**DOCKET NUMBER 50-483
CALLAWAY PLANT
UNION ELECTRIC COMPANY
RESPONSE TO REQUEST FOR ADDITIONAL INFORMATION
ON REVISION TO TECHNICAL SPECIFICATION 5.5.9
"STEAM GENERATOR (SG) TUBE SURVEILLANCE PROGRAM"**

**REQUEST FOR ADDITIONAL INFORMATION
REVIEW OF THE CALLAWAY PLANT APPLICATION
FOR REVISION TO TECHNICAL SPECIFICATION 3/4.4
TAC NUMBER: MB1214**

Figure R30-7

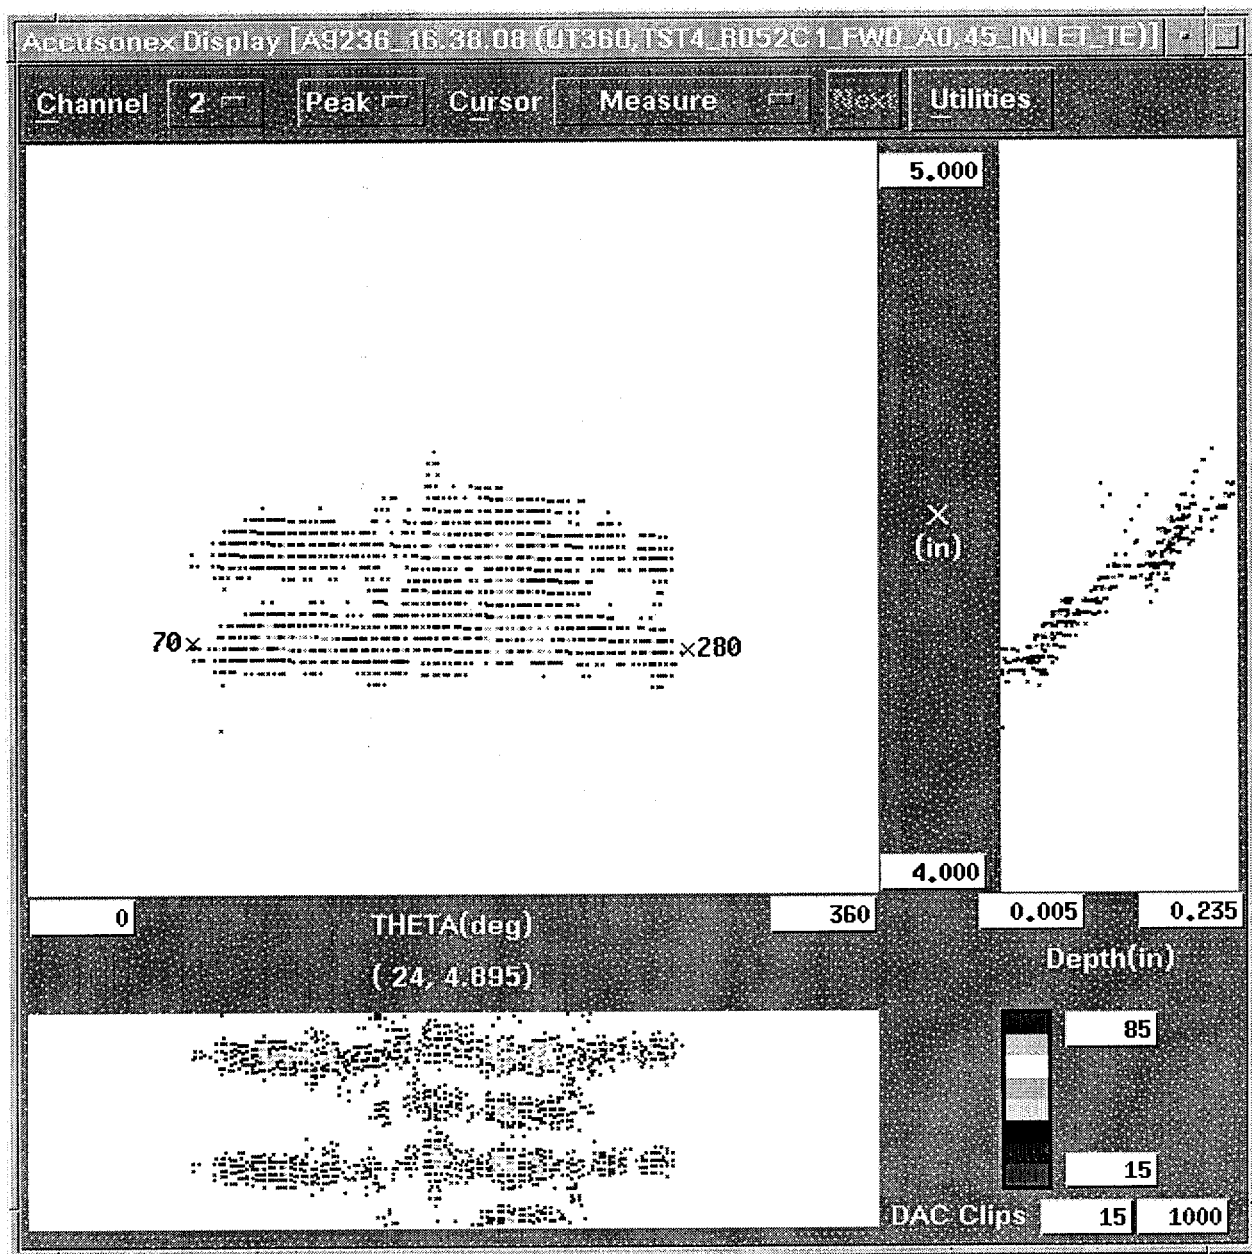
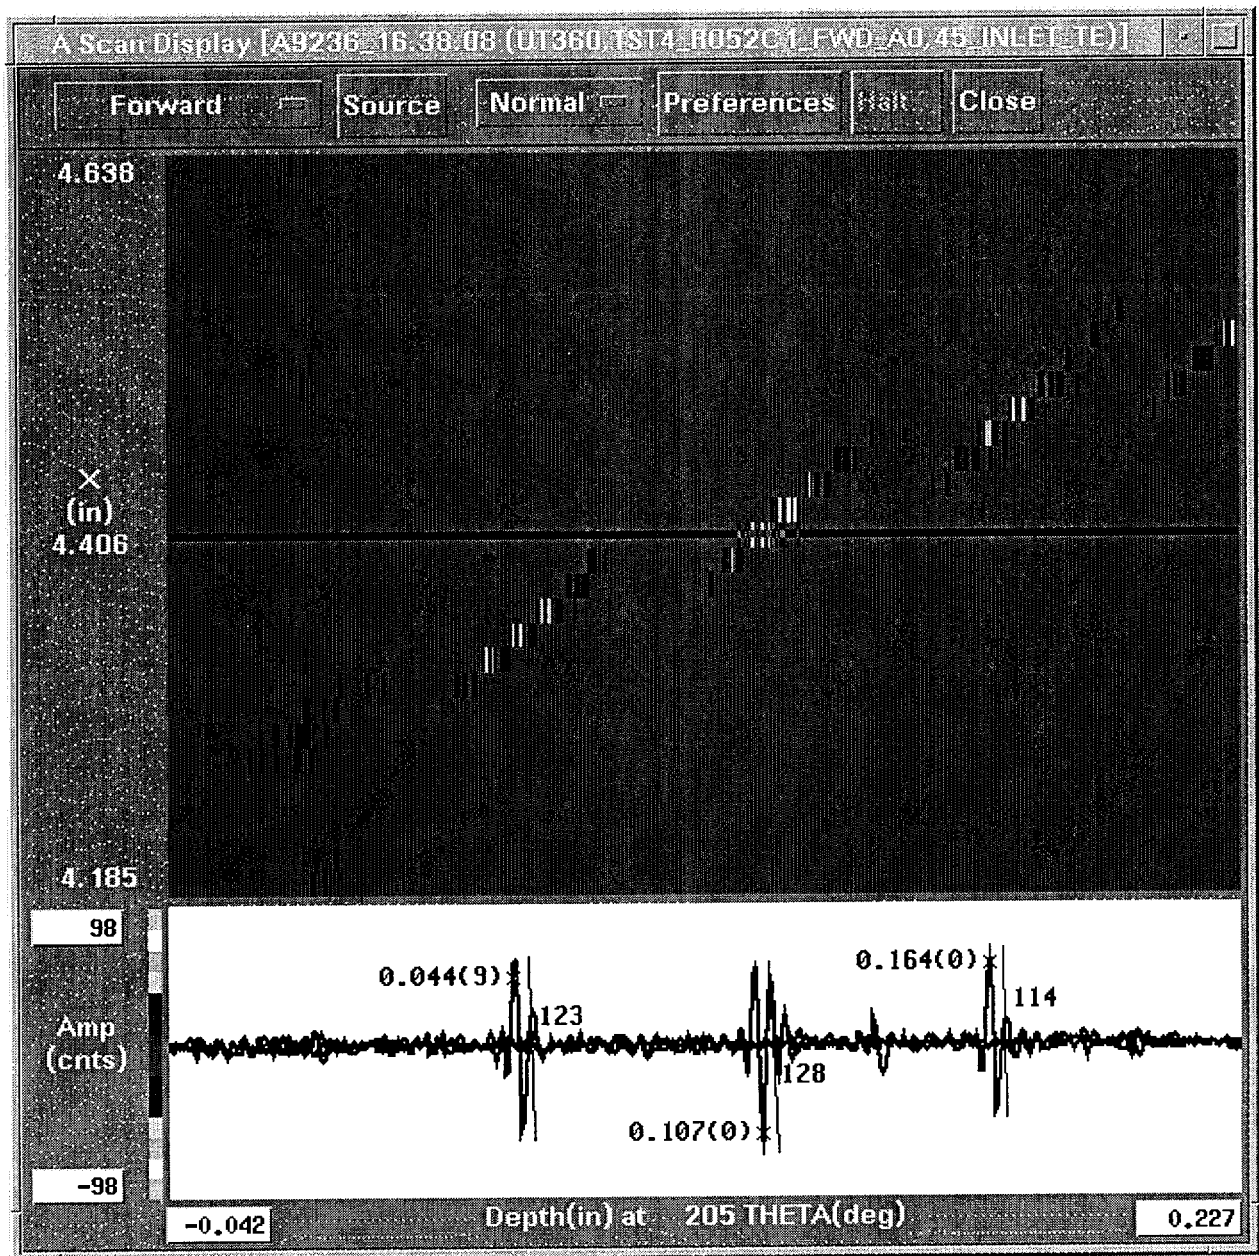
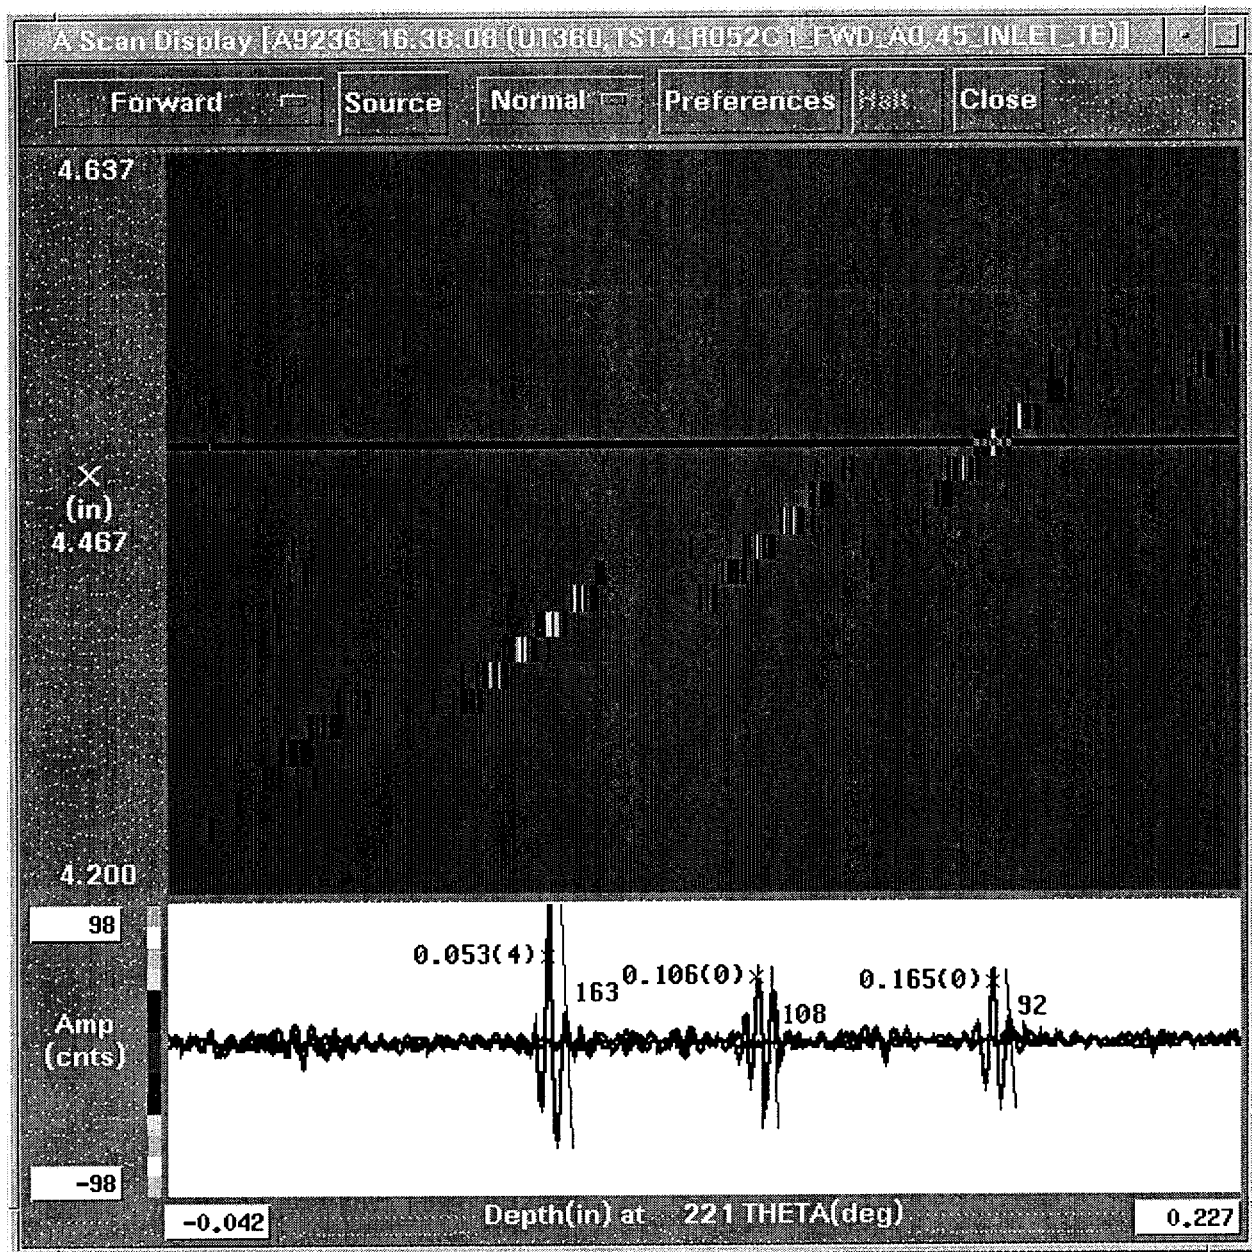
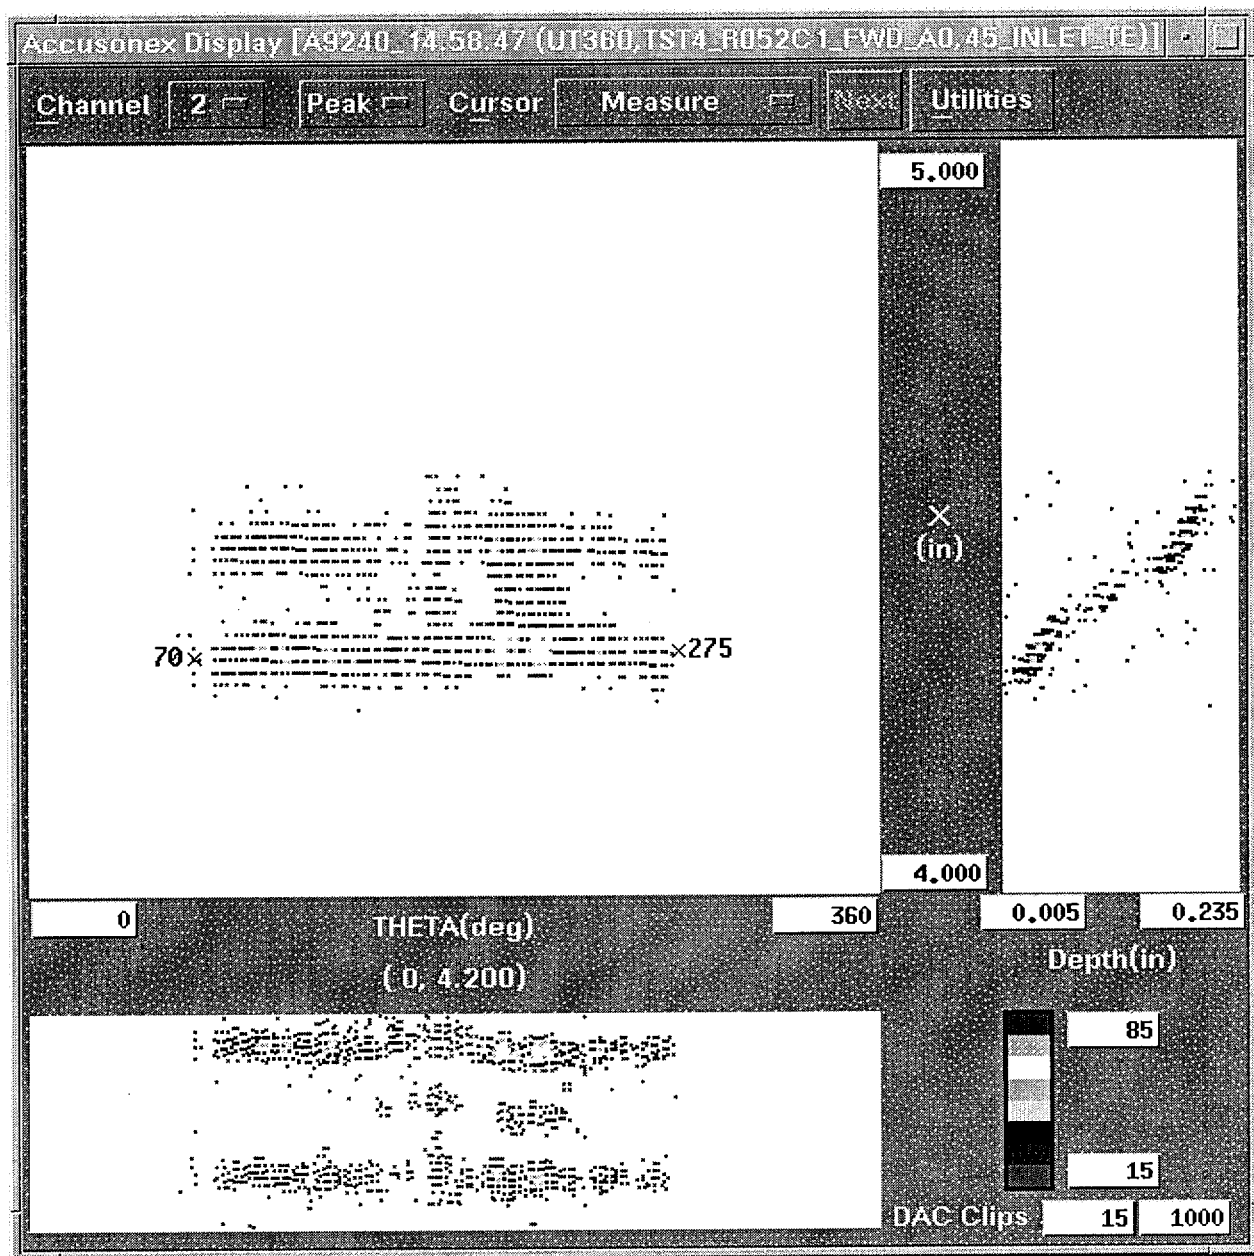
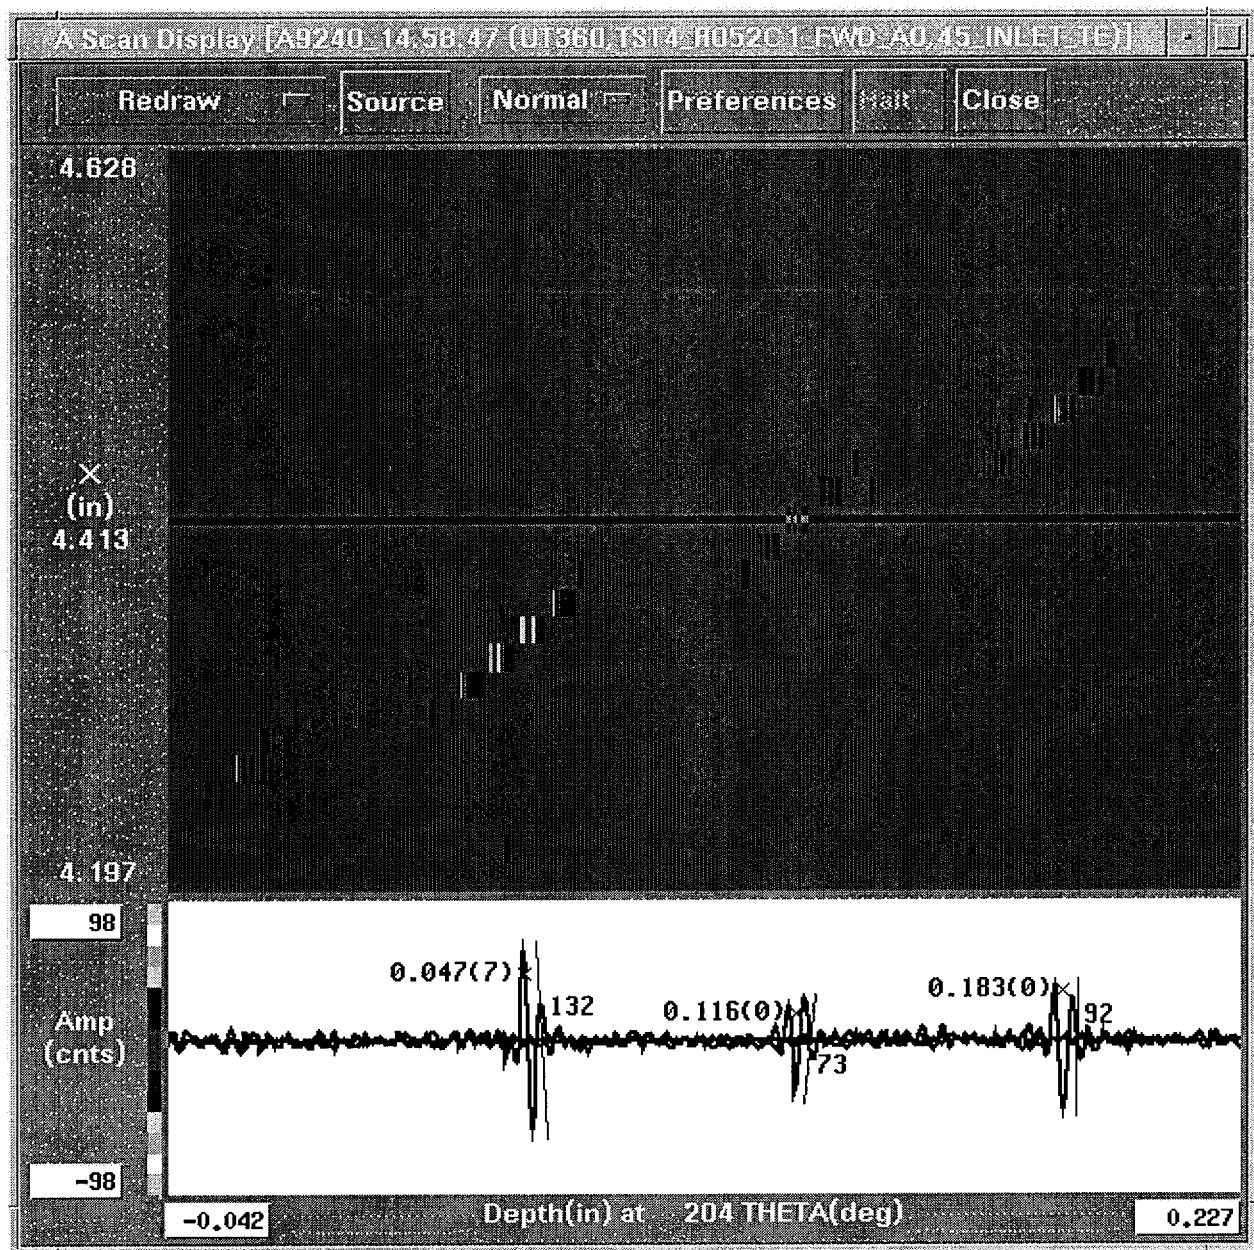
RAI # 30. The report states that “UT techniques have been shown to be effective in the detection and sizing of fatigue cracks propagated into the sleeve material.” Please provide data to support this assertion. (Page 11-57, BAW-10219P, Rev. 4)

This is the pre-fatigue crack C-Scan plot of the ODSCC circumferential crack in tube TST4-072-1. The crack extent (length) can be estimated from the C-Scan plot as $(278 - 85)$ or 193 degrees. The plot shows the presence of a half skip response, a one and one half skip response and some full skip reflections.

This is the post-fatigue crack C-Scan plot of the ODSCC circumferential crack in tube TST4-072-1. The crack extent (length) can be estimated from the C-Scan plot as $(275 - 80)$ or 195 degrees. The fatigue cycling has not significantly increased the crack extent (length). The plot shows the presence of a half skip response, a one and one half skip response and an increase in the full skip response.

This is the pre-fatigue crack C-Scan plot of the ODSCC circumferential crack in tube TST4-052-1. The crack extent (length) can be estimated from the C-Scan plot as $(280 - 70)$ or 210 degrees. The plot shows the presence of a half skip response, a one and one half skip response and some full skip reflections between the 148 degree and 234 degree locations along the crack extent.

This is the post fatigue crack C-Scan plot of the ODSCC circumferential crack in tube TST4-052-1. The crack extent (length) can be estimated from the C-Scan plot as (280 – 70) or 210 degrees. The plot shows the presence of a half skip response, a one and one half skip response and an increase in the full skip response between the 200 degree and 230 degree locations along the crack extent.

This is the post final deposition C-Scan plot of the ODSCC circumferential crack in tube TST4-052-1. The crack extent (length) can be estimated from the C-Scan plot as (275 – 70) or 205 degrees. The plot shows the presence of a half skip response, a one and one half skip response and the diminished amplitude of the full skip response.
